# CEREC SW 5.2.4

## Update Description (EN)

### Changes made to previous version 5.2.3:

- New materials:

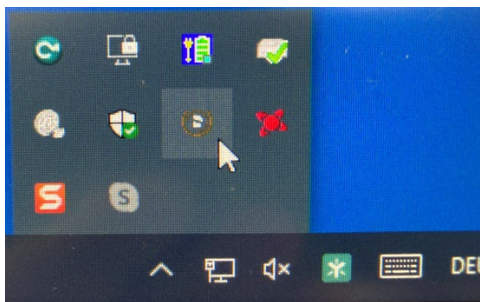
Manufacturer	Material	Customization
Dentsply Sirona	CEREC Tessera Abutment	Activation of MIS Ti bases in CE
Dentsply Sirona	CEREC Tessera Abutment	Design parameter adjustment for indication mesostructure/ abutment from 1.0 mm to 0.0 mm
Dentsply Sirona	CEREC MTL Zirconia	Multijob option for SpeedFire - up to 3 restorations of the same color can be sintered in SpeedFire
3M	Chairside Zirconia	Multijob option for SpeedFire - up to 3 restorations can be sintered in SpeedFire
